RE: 150 Steeles Avenue East and 248, 250 & 314 Martin Street, Milton, Proposed Mixed-Use Development

This memorandum is intended to provide additional information to address the Town’s transportation-related comments dated April 2, 2026 and April 8, 2026, and the Region’s transportation comments dated April 17, 2026, in regard to BA Group’s February 2026 Transportation Considerations Report (“the February 2026 BA Group Report”). We trust that the enclosed memorandum provides the appropriate information requested by the Town. Please feel free to let us know if you have any questions or require any additional information.

1.0 BA GROUP RESPONSES TO TOWN COMMENTS

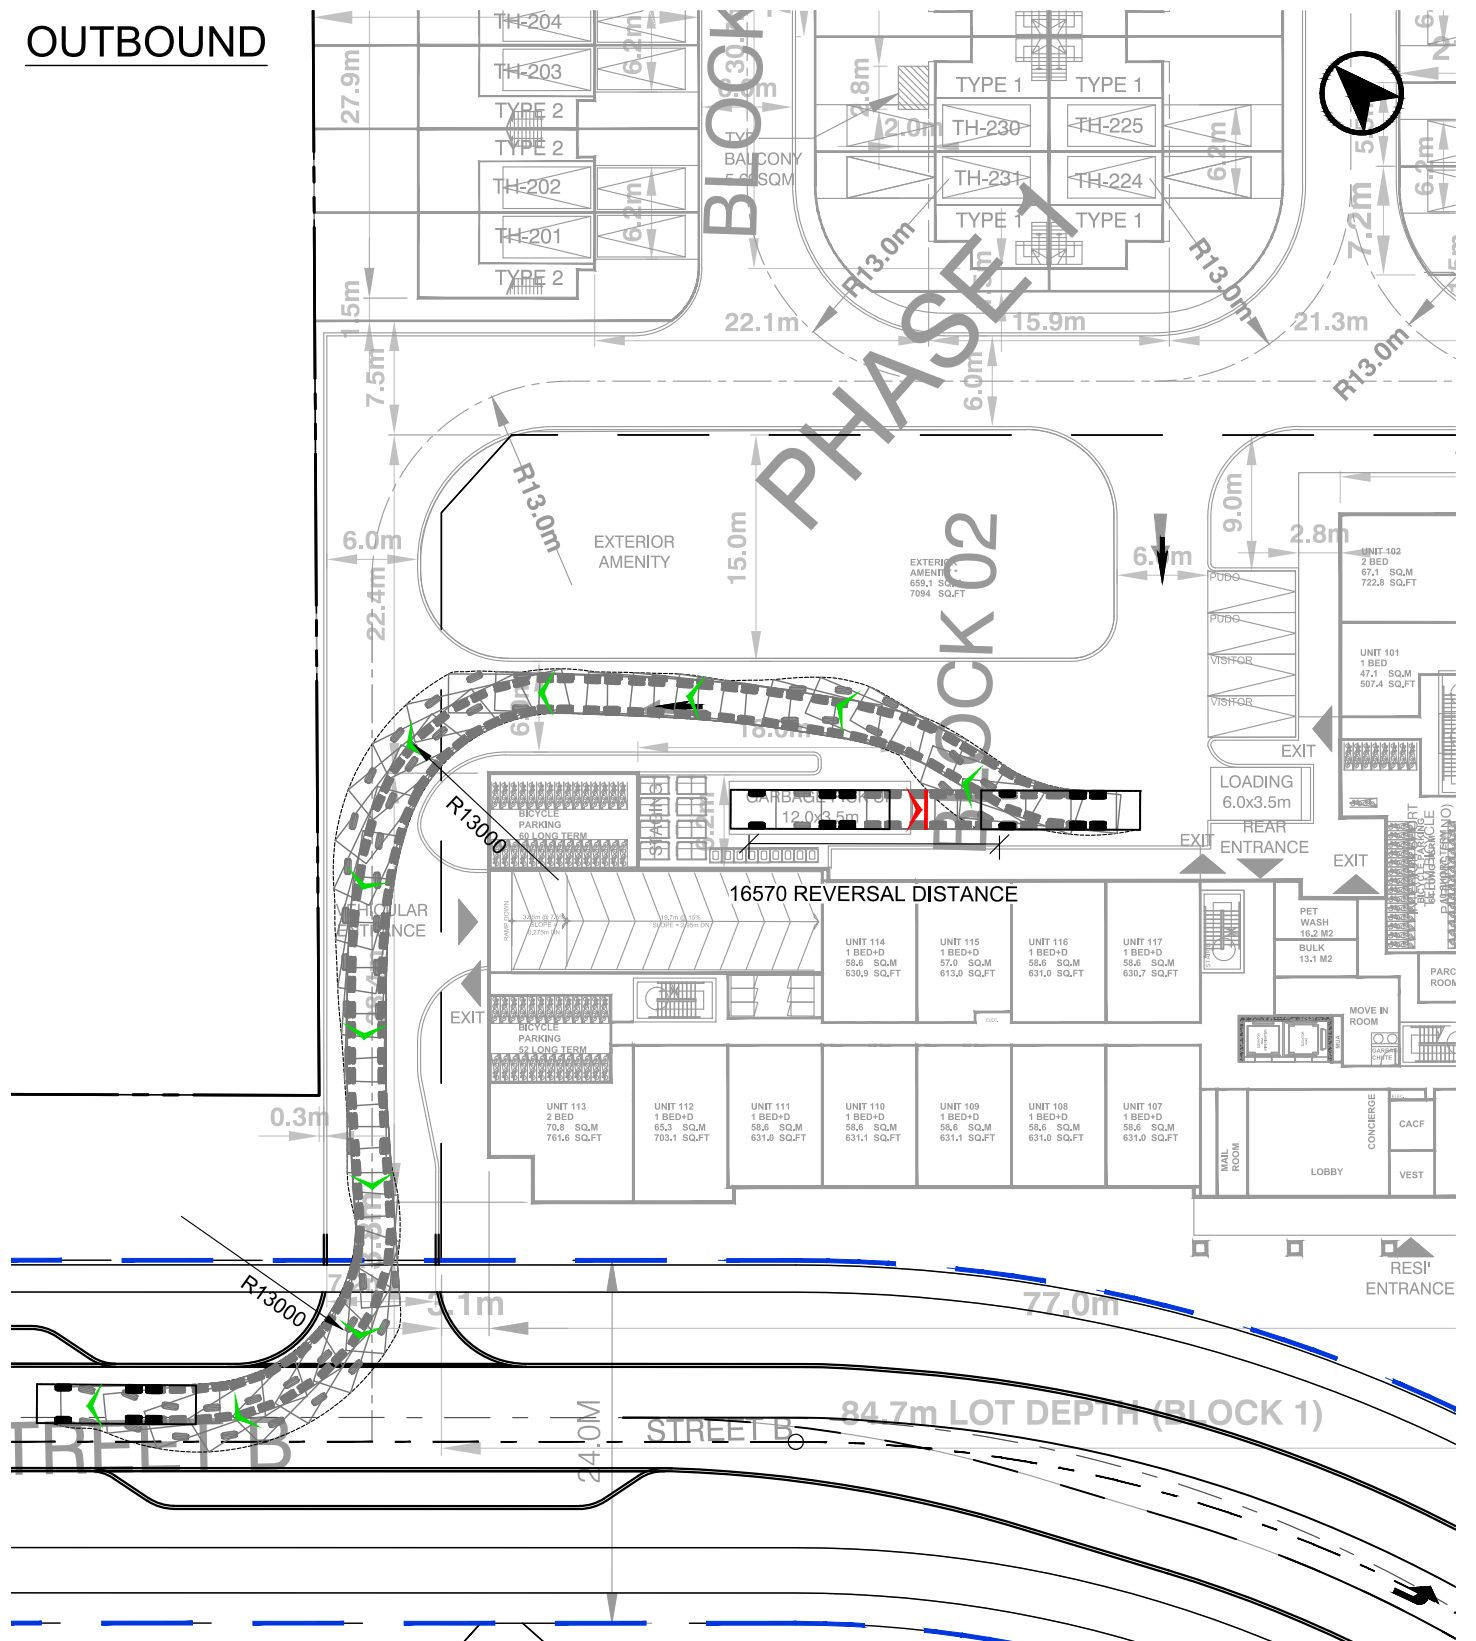
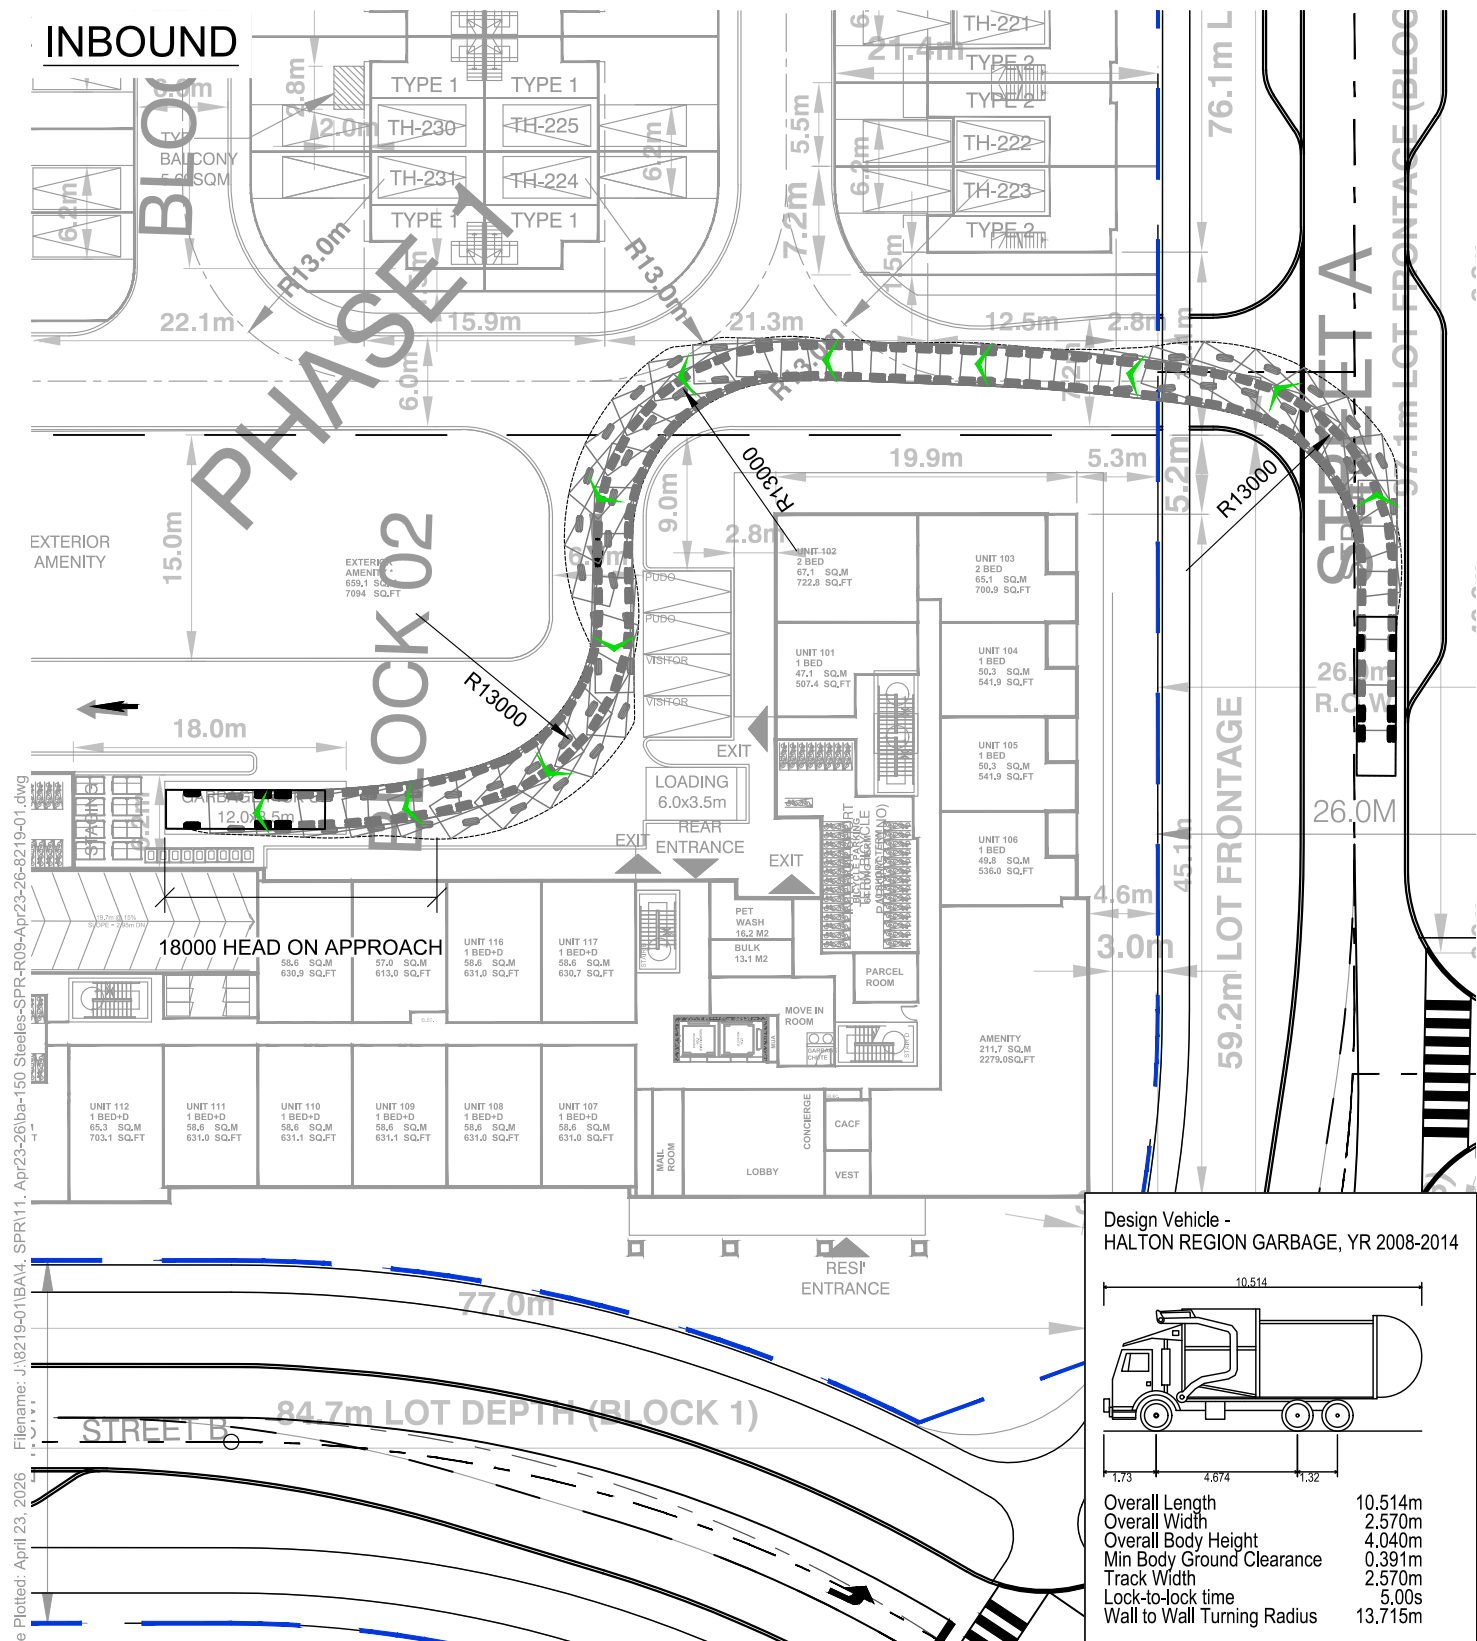
-Ideally, we do not reduce daylight triangles at intersections. Considering this is a RT/RT, can you provide some justification, and I can certainly consider that to move things forward. Please let me know what dimensions you are considering as well.
